MORGANTOWN BOARD OF ZONING APPEALS

COMBINED STAFF REPORT

CASE NO: V16-40, V16-41, and V16-42 / Seneca Village, LLC / 709 Beechurst Ave.

PLANNING AND ZONING CODE CONFORMITY REPORT

PHASE No.	LANDSCAPE PLAN	SHEET No.
CONTRACT No.	PISON DEVELOPMENT - SENECA VILLAGE	C4.00
PROJECT No.	MORGANTOWN, WV	
	10/24/2016	
	SCHEMATIC DESIGN

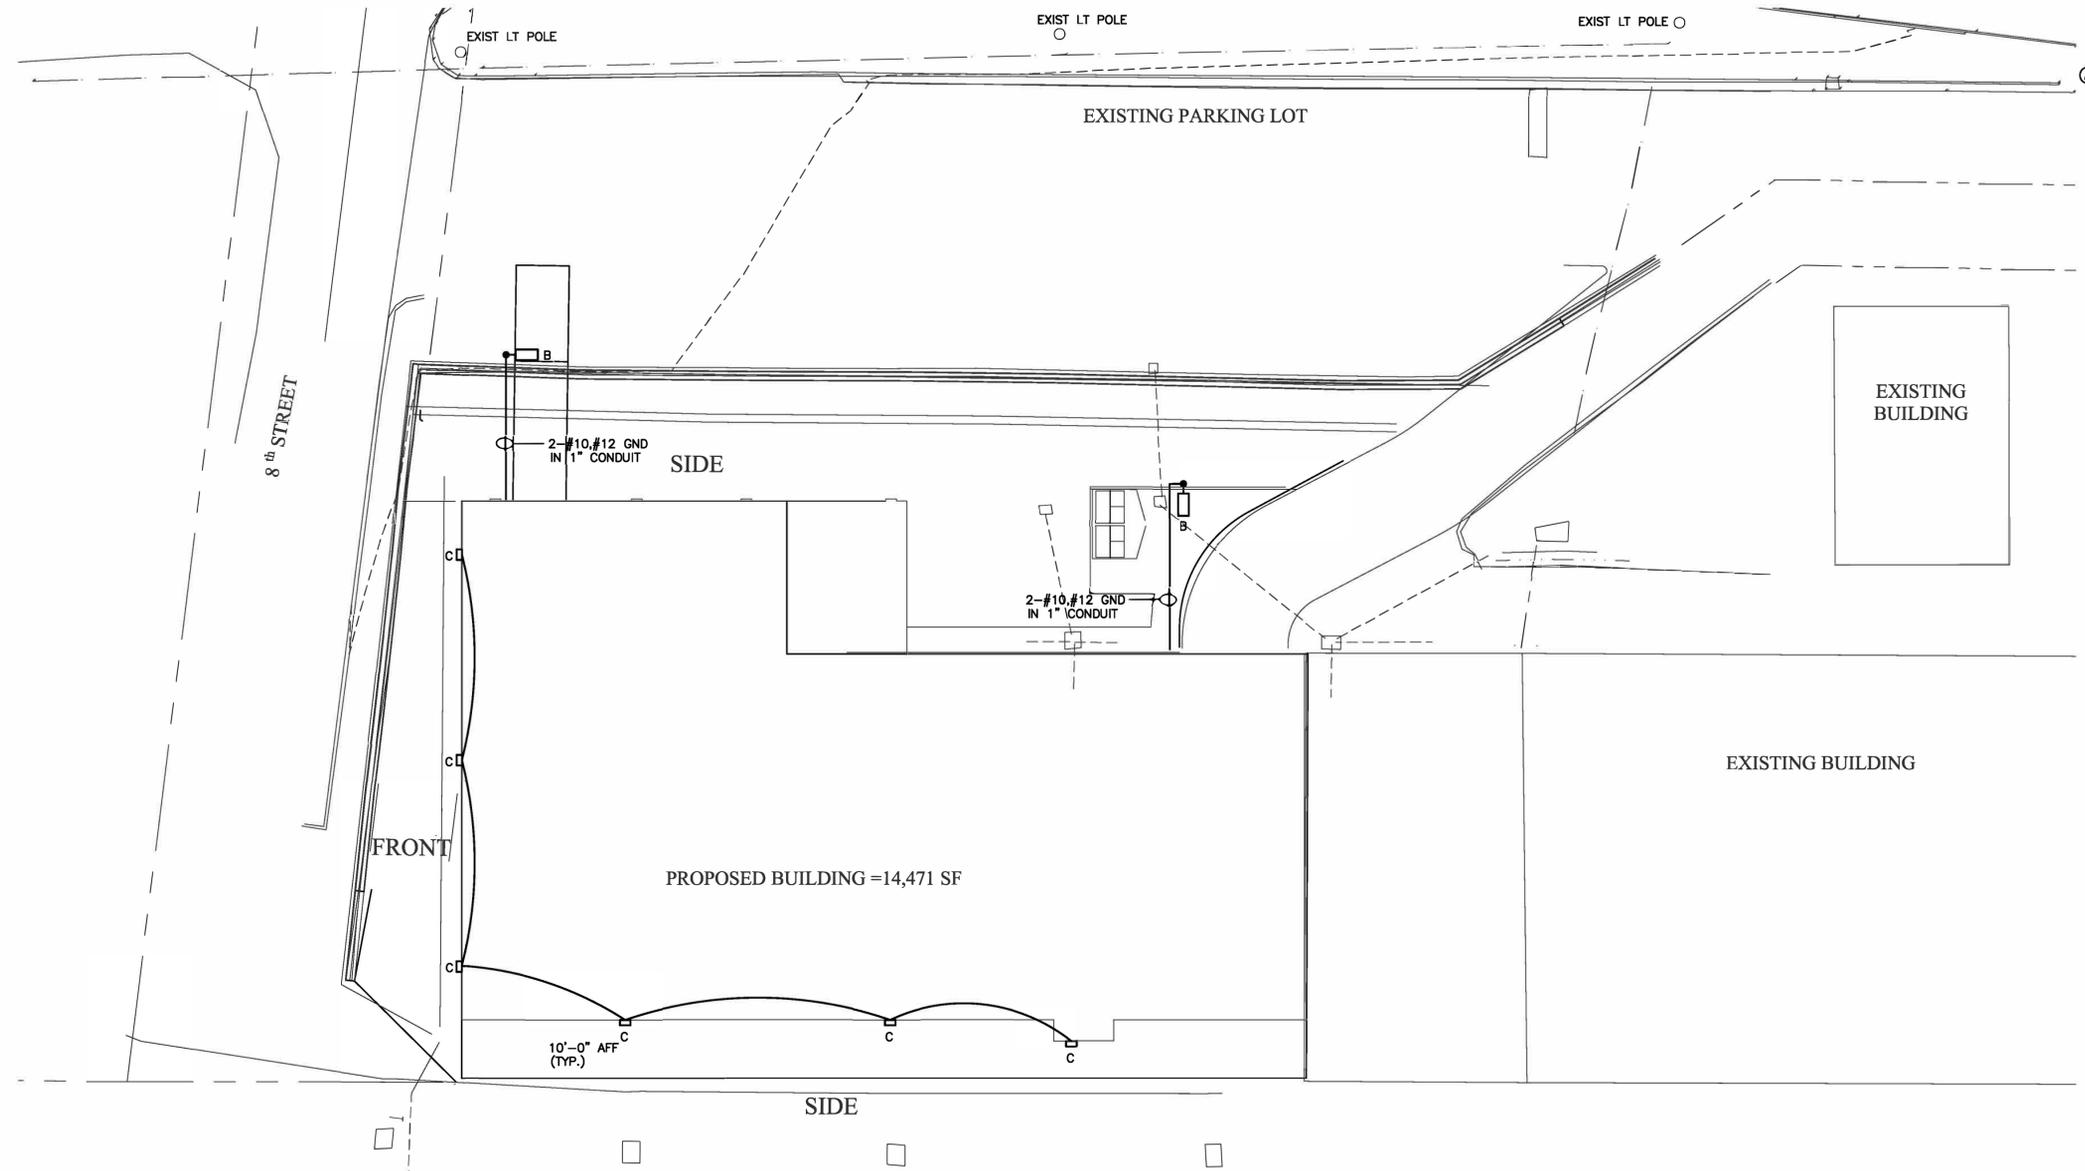
TBD	<i>A preliminary Landscaping Plan is provided on Sheet C4.00. Conformity with landscaping requirements will be completed at building permit application.</i>
-----	--

2. That requisite variance approvals identified herein must be granted by the Board of Zoning Appeals and related conditions observed.
3. That, to the satisfaction of the Planning Division, the final Landscape Plan and Lighting Plan must be submitted, reviewed and approved and variance relief granted, if required, prior to the issuance of any development related building permits.

SHEET No.
4.01

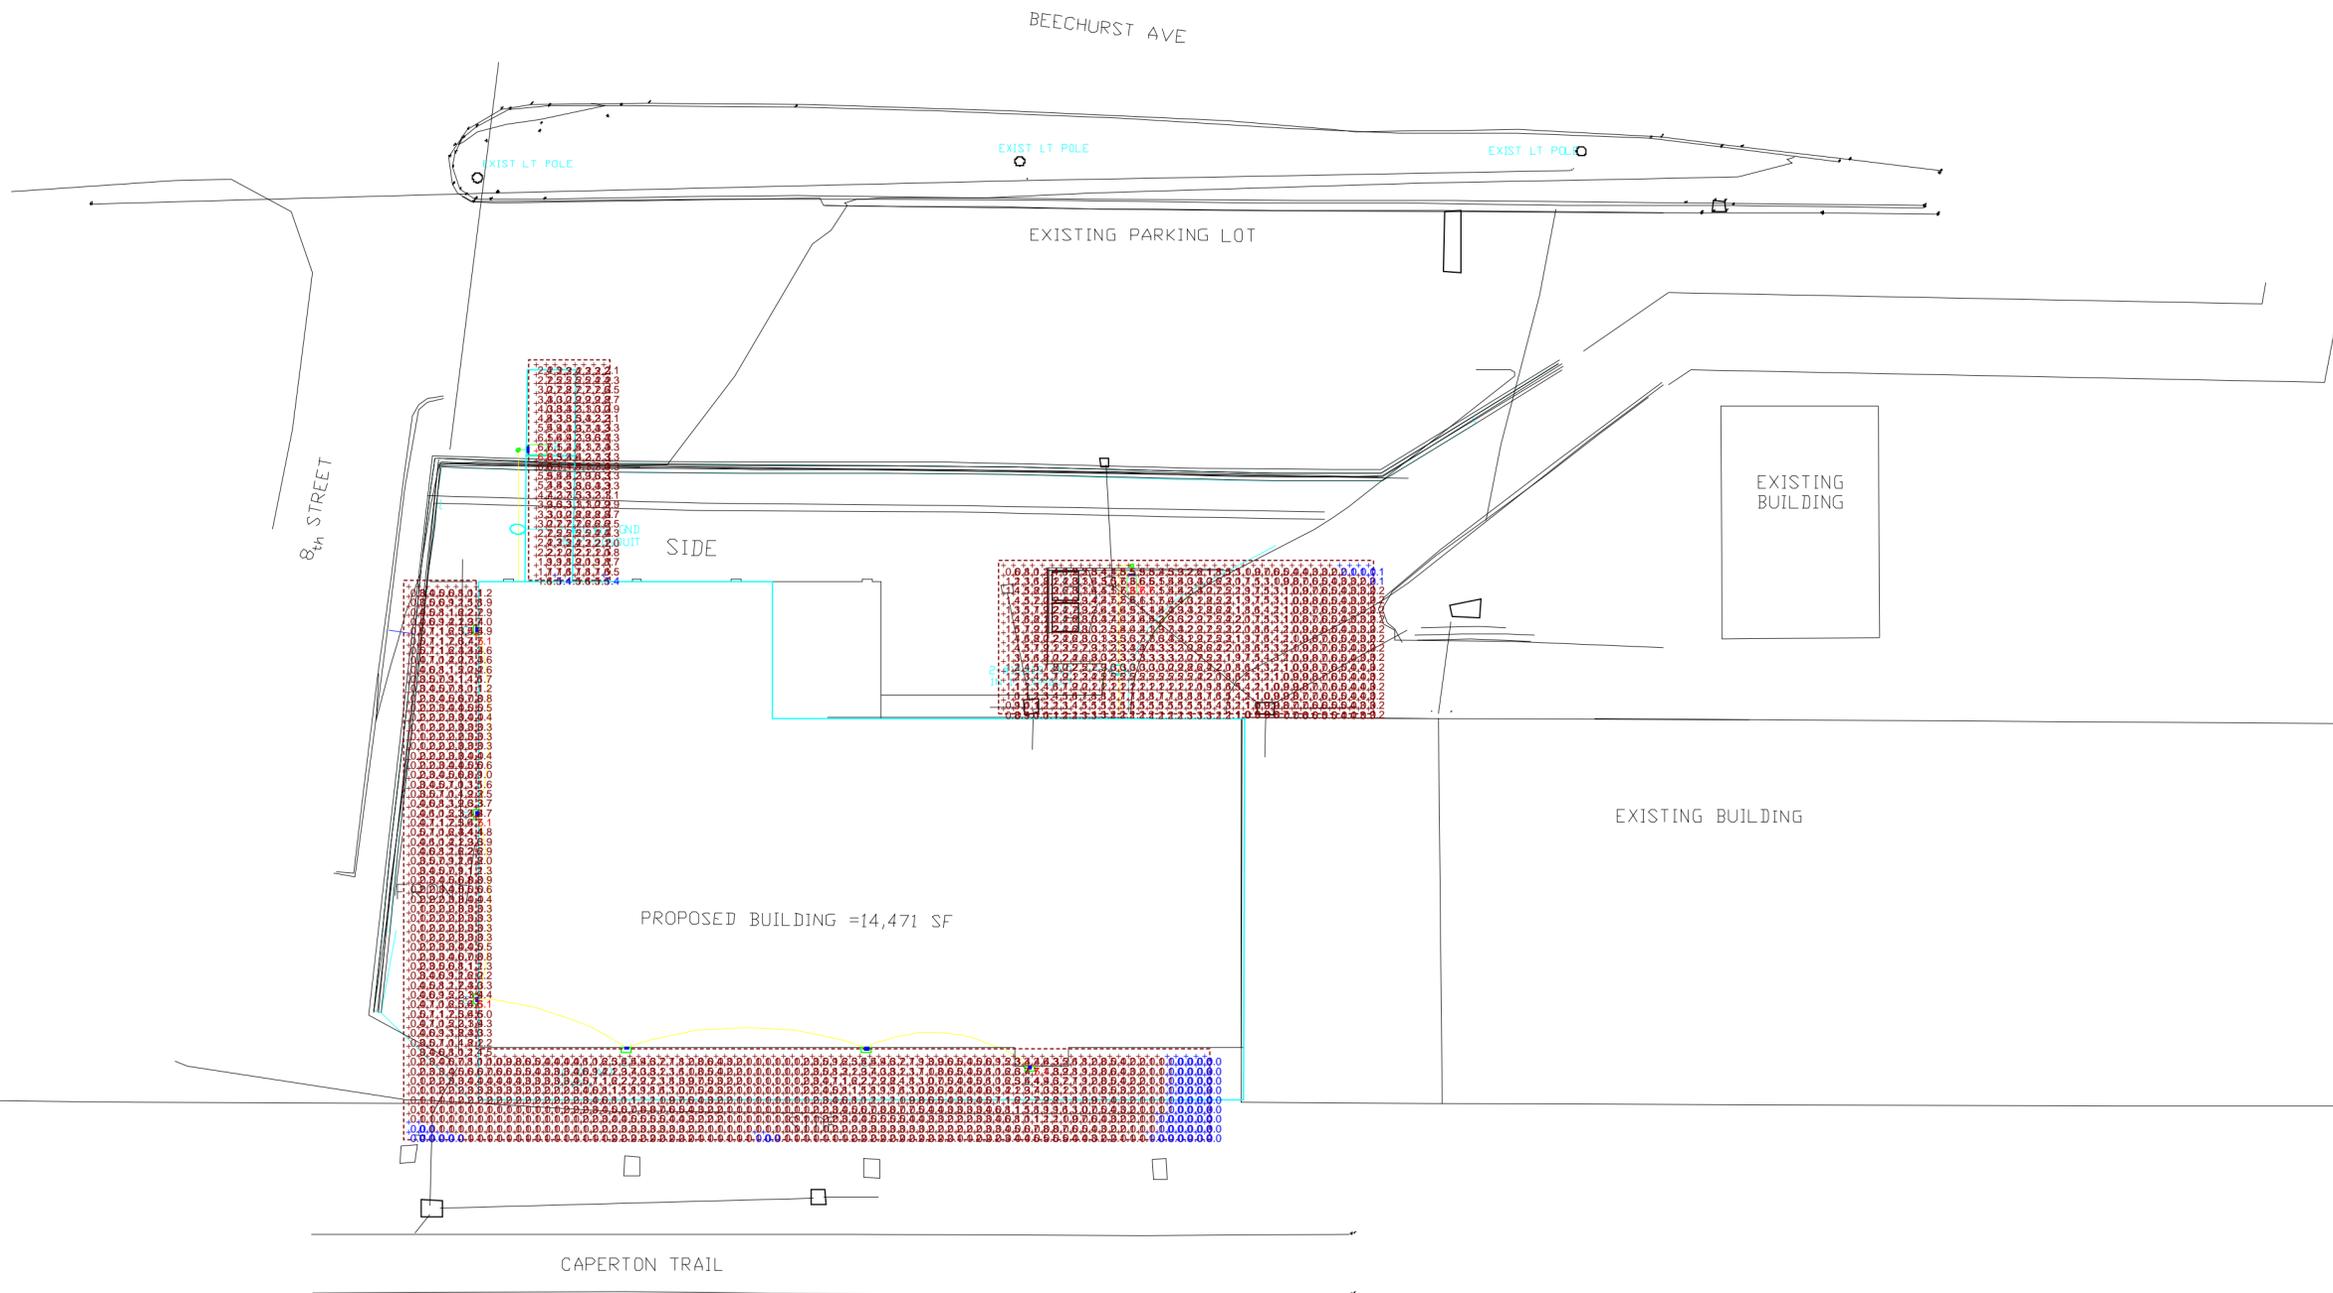
<i>The preliminary Lighting Plan provided on Drawing No. 1 prepared by “Visual” requires modifications to improve legibility. Conformity with lighting requirements will be determined a building permit application.</i>

<i>The preliminary Lighting Plan provided on Drawing No. 1 prepared by “Visual” requires modifications to improve legibility. Conformity with lighting requirements will be determined a building permit application.</i>
1365.09 Parking Development Standards – Surfacing and Drainage.	
TBD	(C)(1) All open off-street parking areas shall be surfaced with an all-weather, dust-free concrete or asphalt material, and shall be maintained in good condition and free of weeds, dirt, trash and debris; except that, a gravel surface may be used for a period not exceeding six months after the date of granting the Certificate of Occupancy where ground conditions are not immediately suitable for permanent surfacing as specified above.
	<i>Paving will be required for the integral parking area. Paving design along with stormwater management will be reviewed and approved by the Morgantown Utility Board (MUB) and the City Engineer at building permit application.</i>

TBD	<i>The preliminary Lighting Plan provided on Drawing No. 1 prepared by "Visual" requires modifications to improve legibility. Conformity with lighting requirements will be determined a building permit application.</i>
-----	---

SHEET No.
A6.00

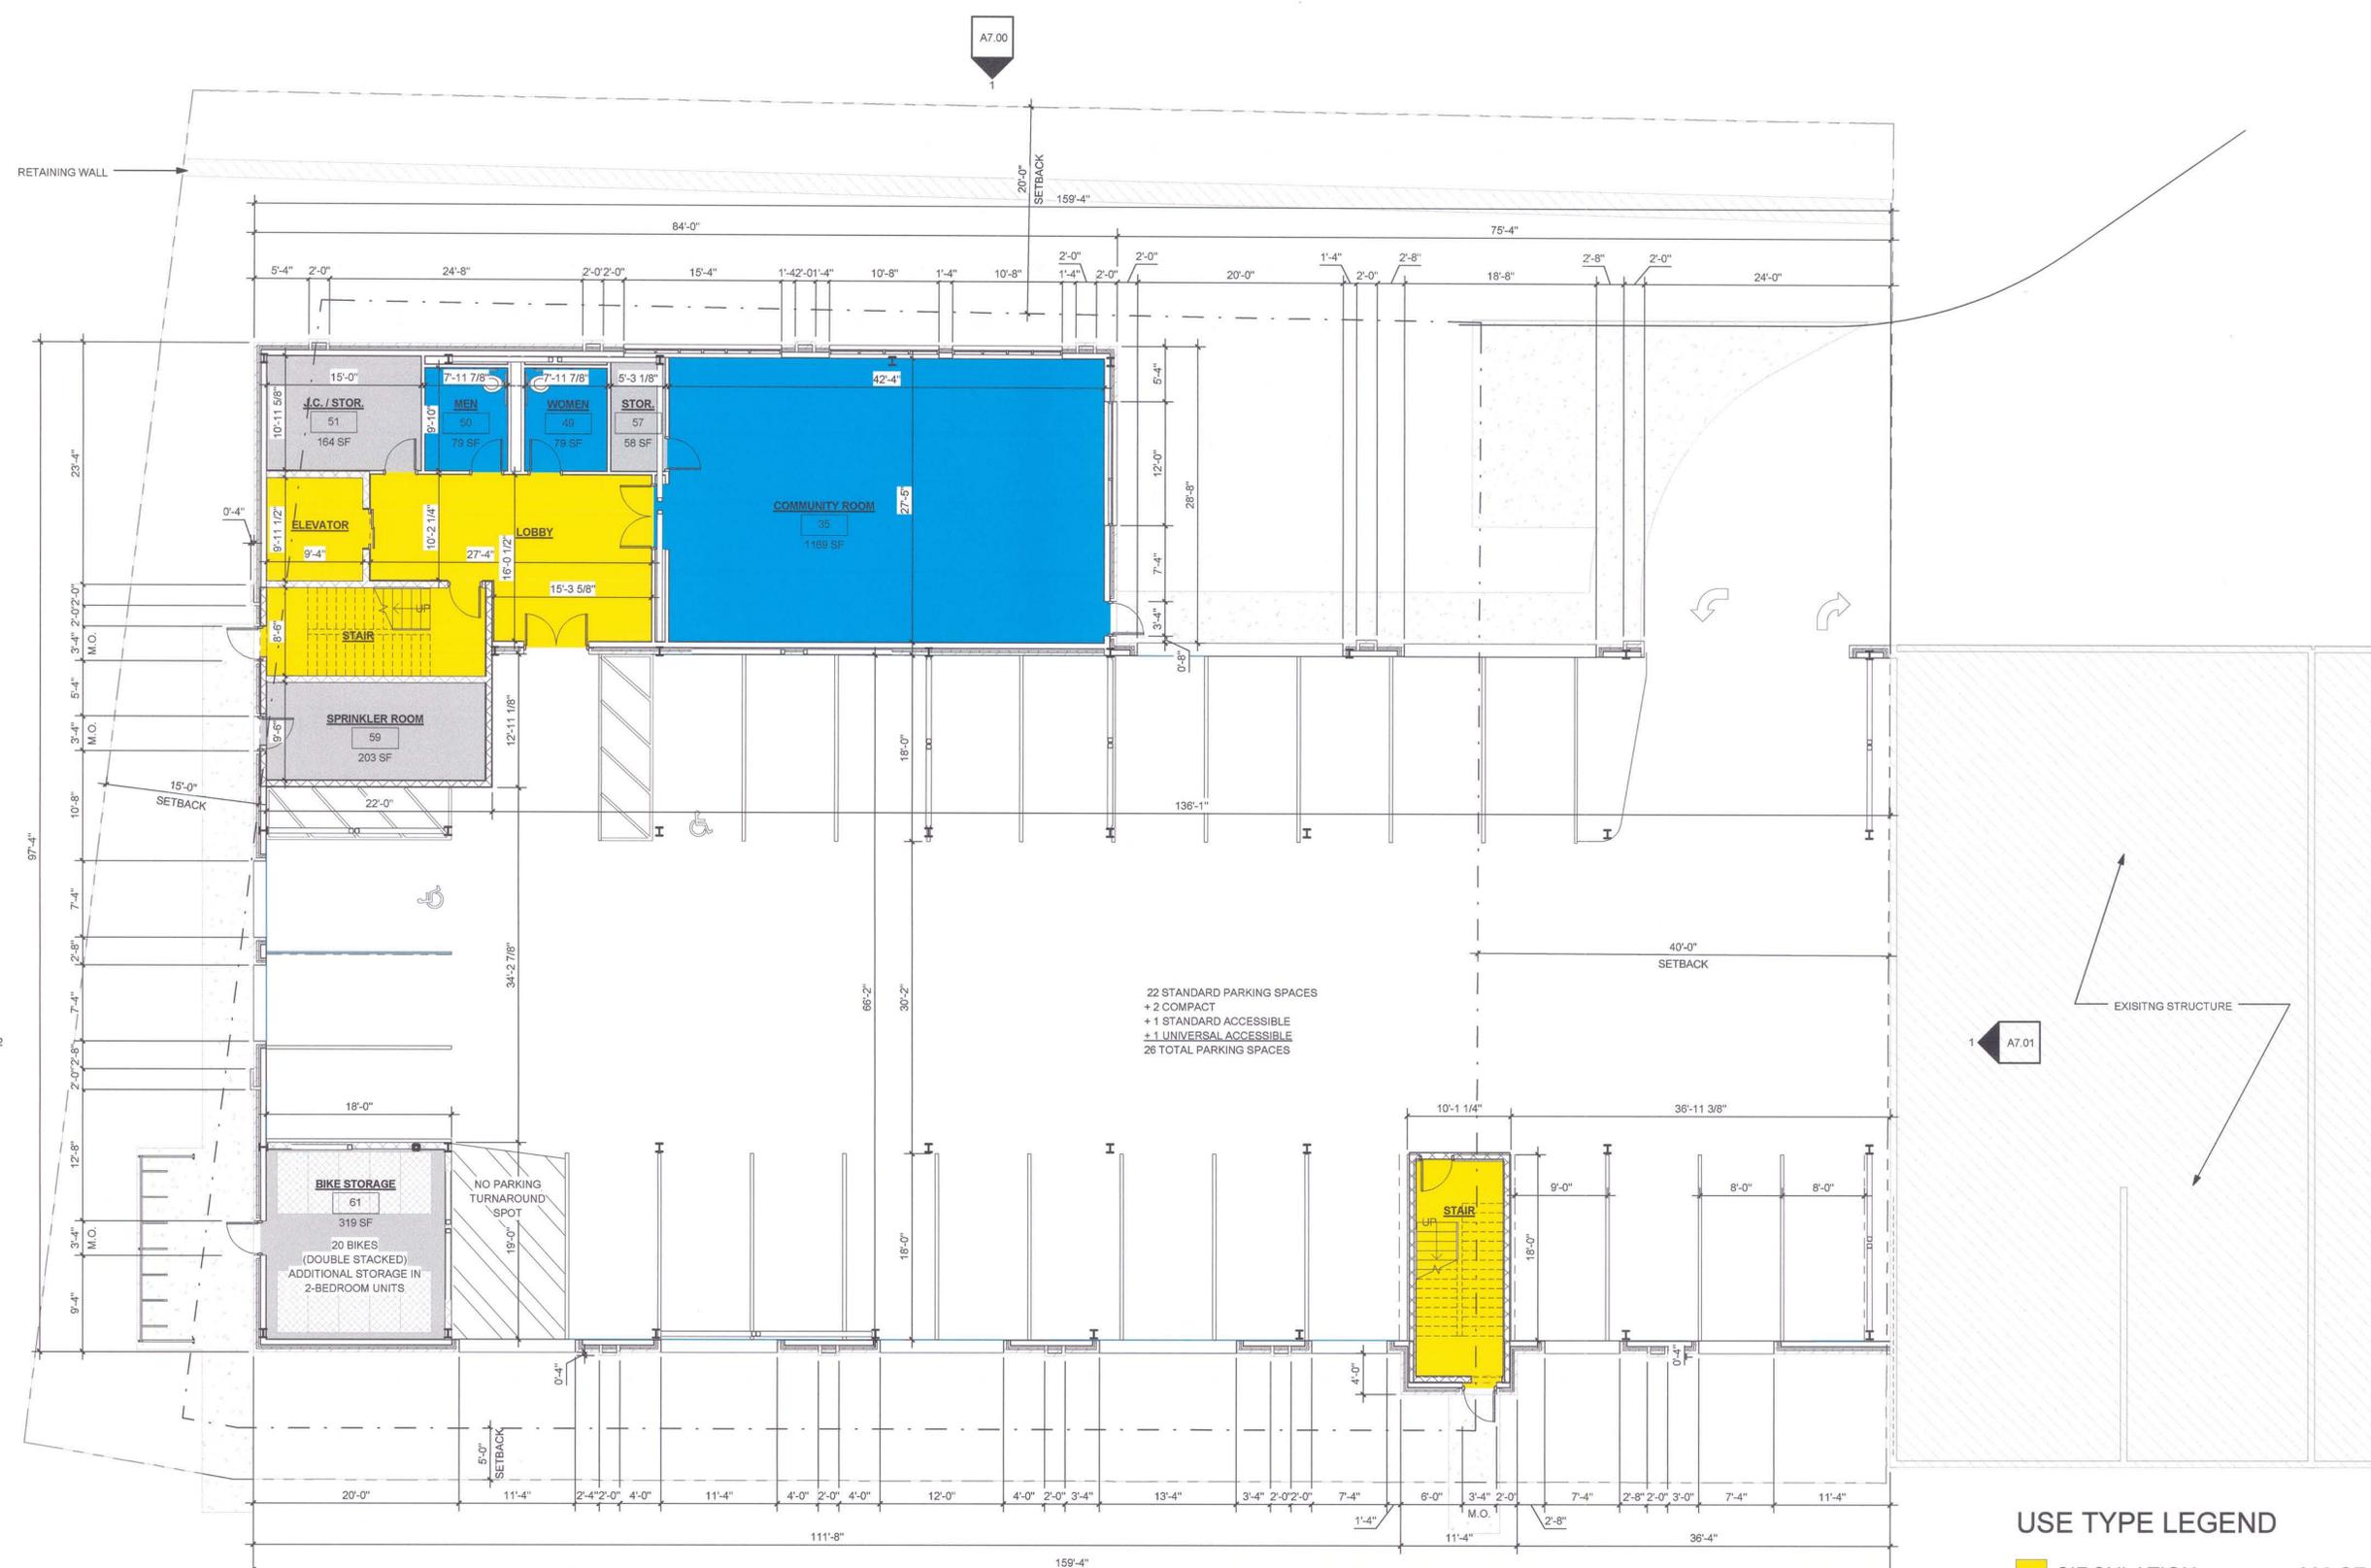
- The first level parking plan includes 26 90-degree parking stalls, 2 of which are accessible spaces (1 universal designed space).
- Project delivery is anticipated for JAN 2018 following an anticipated construction schedule of approximately 12 months.
